APPENDED FIELD SAMPLING PLAN FOR TASK ORDER 1

**RCRA Facility Investigation/Corrective Measures
Study (RFI/CMS) and Base Closure Environmental
Study for the Lexington-Blue Grass Army Depot**

AMENDMENTS/CLARIFICATIONS/ADDITIONS TO THE SAP

**Figure
4-1**

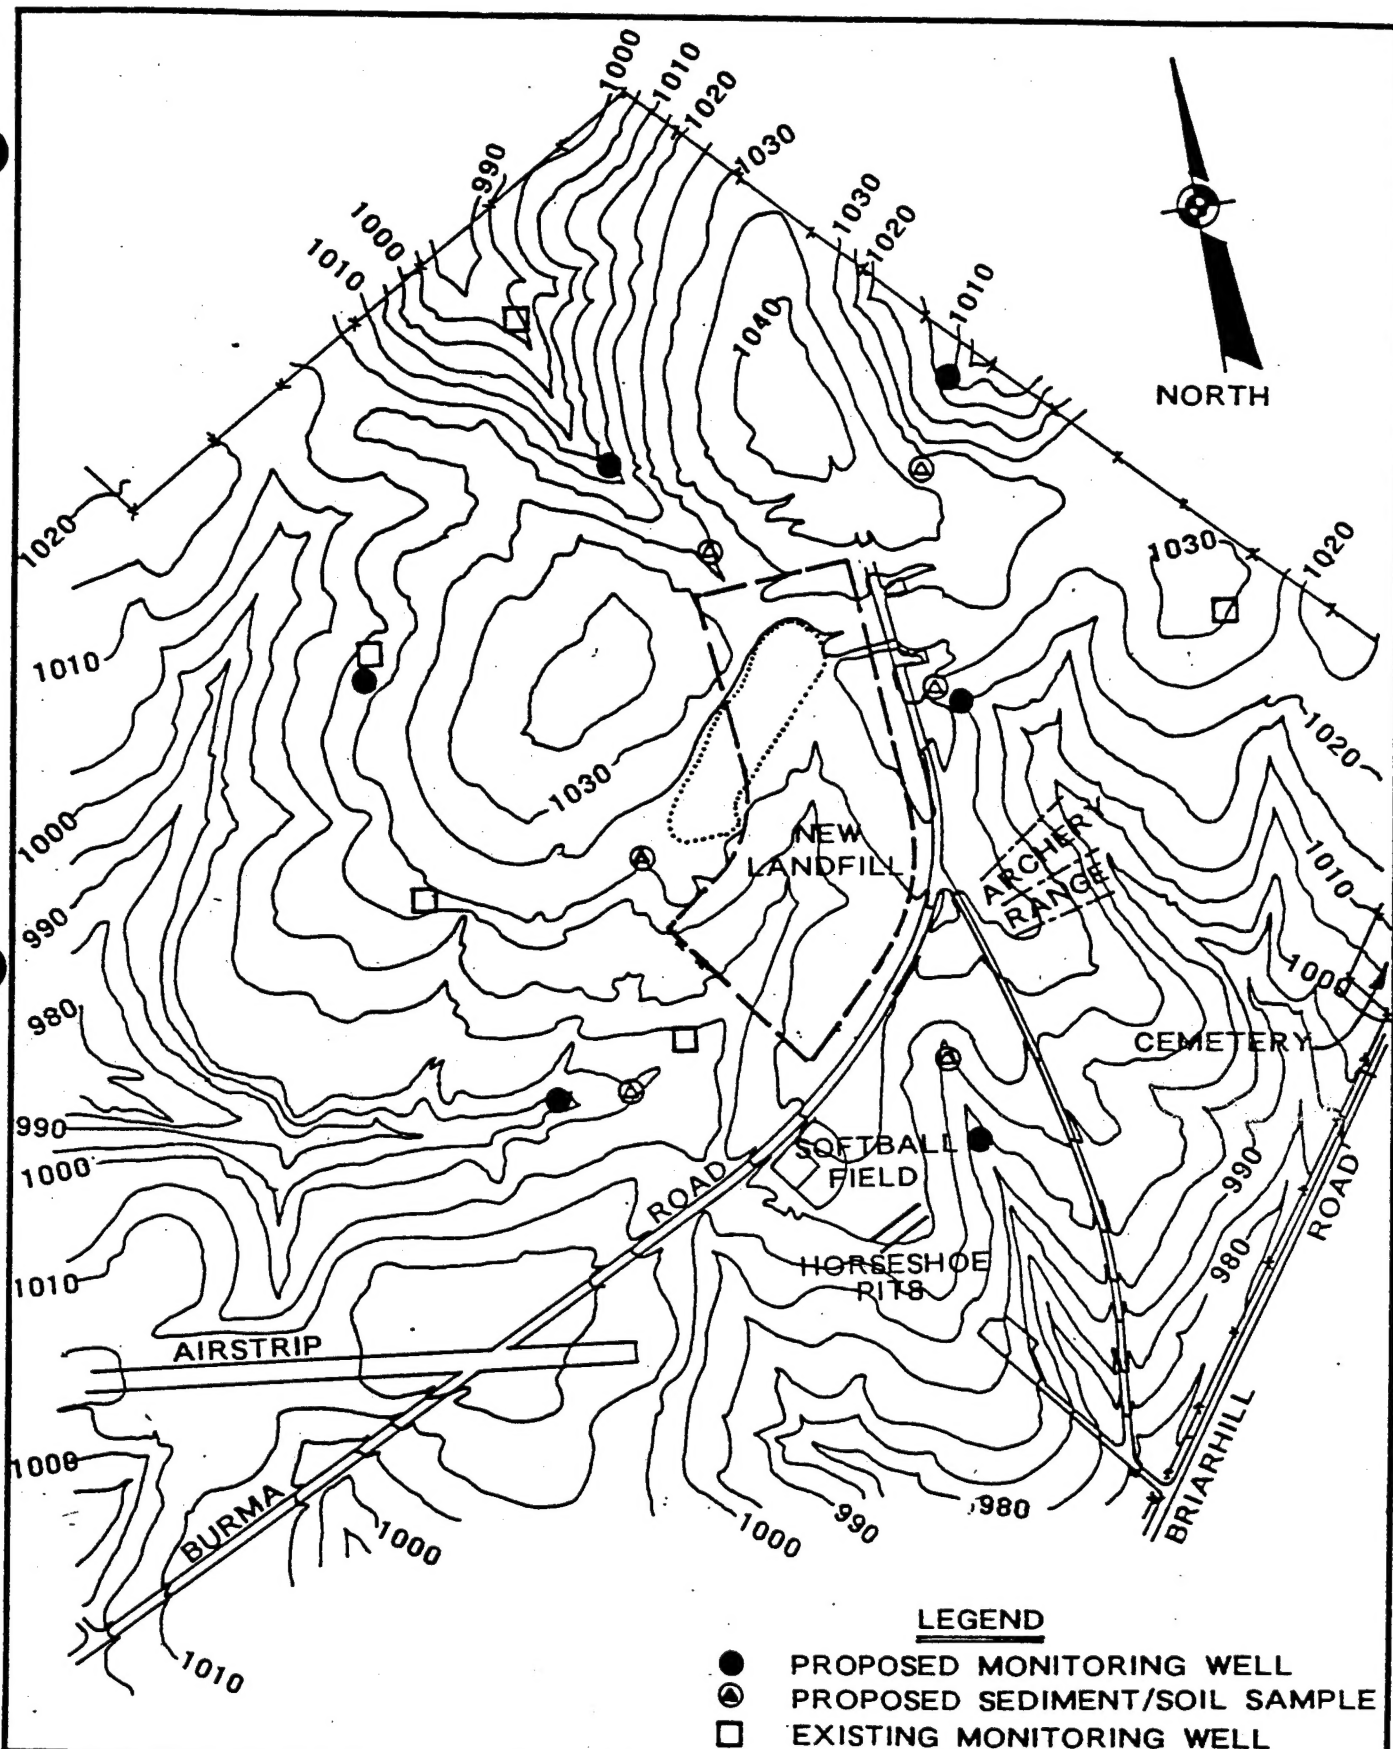
Figure 4-1 revised to show new well and sampling locations. See attached revised map.

Figure
 4-2

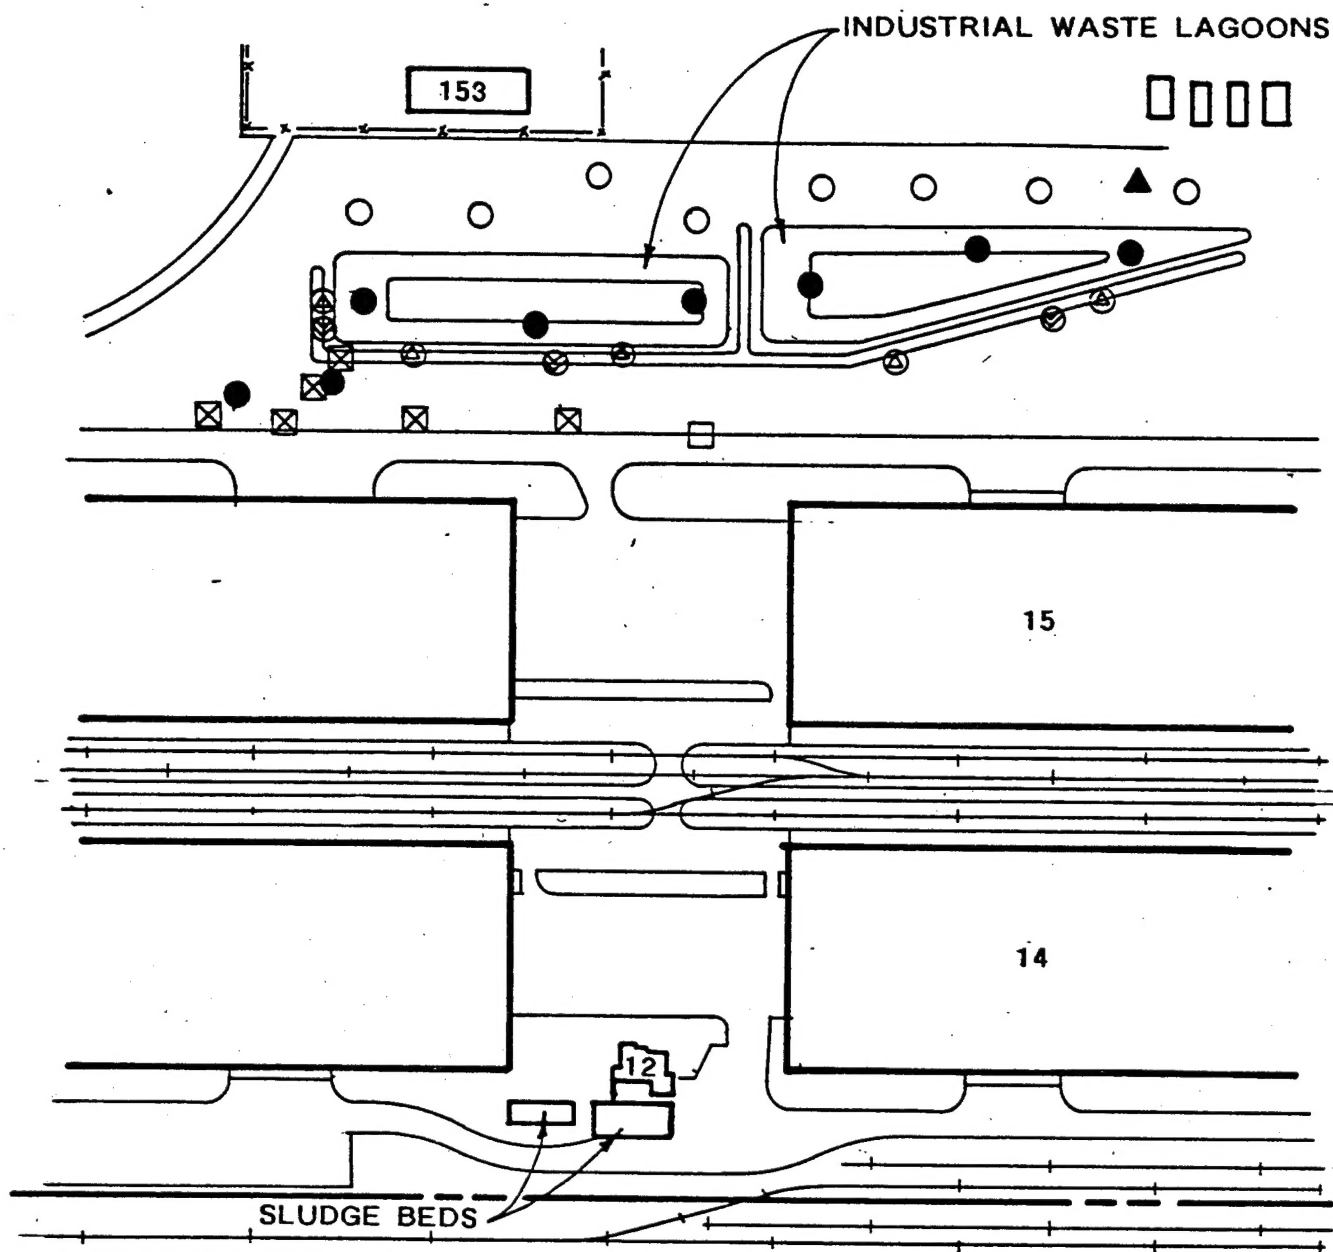
Figure 4-2 revised to show new well and sampling locations. See attached revised map.

Figure
4-13

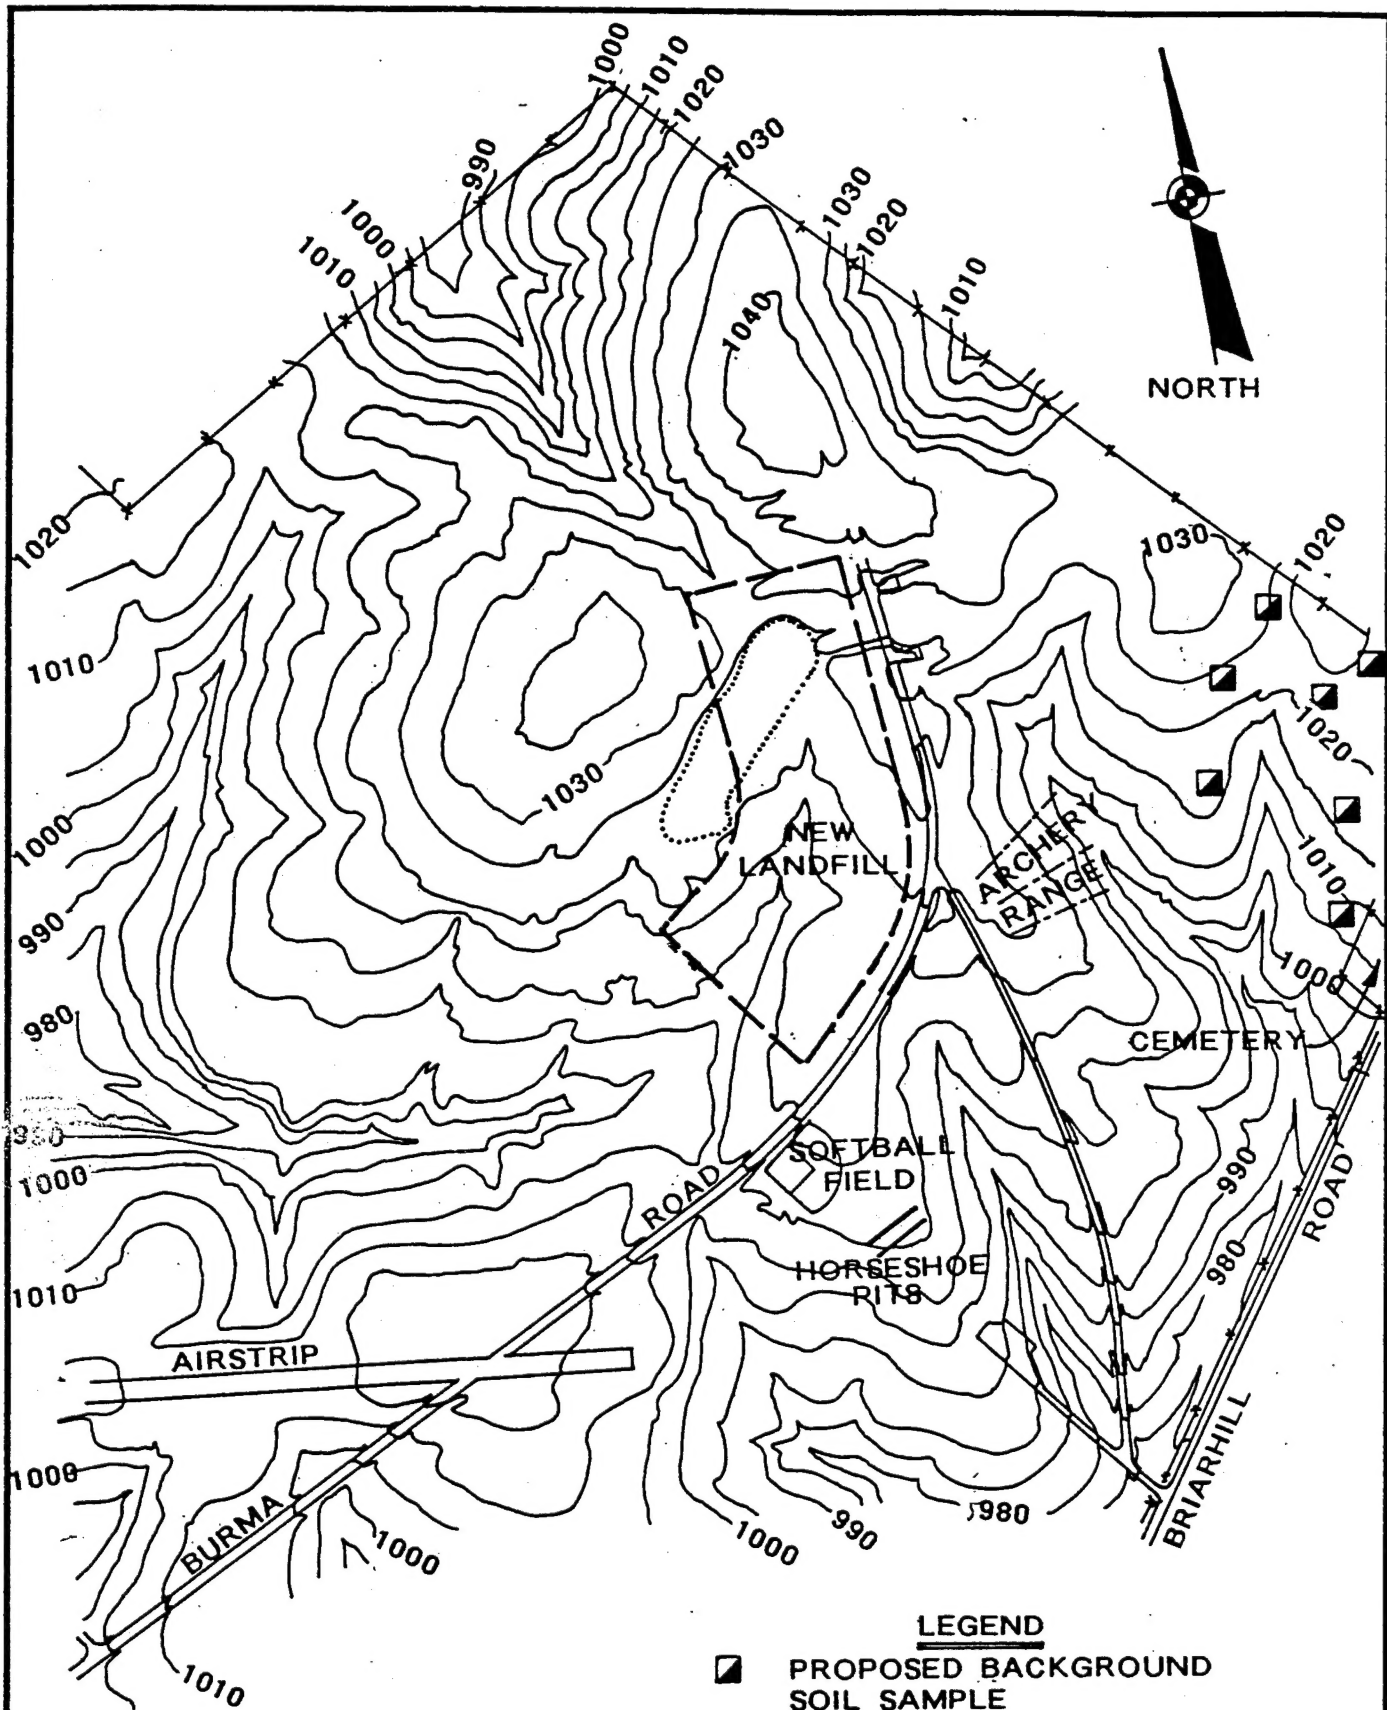
Shallow Soil Borings: Seven (7) shallow soil borings will be drilled within the area described at the locations shown on Figure 4-13. Samples will be collected in the borings at a depth from 0 to 1 foot, 2 to 3 feet or to auger refusal. These samples will be collected according to procedures described in Section 3.11, and will be analyzed for Target Compound List (TCL) compounds (except for Volatiles in the 0 to 1 foot interval.

Figure 4-13 added to show new background sampling locations. See attached map.
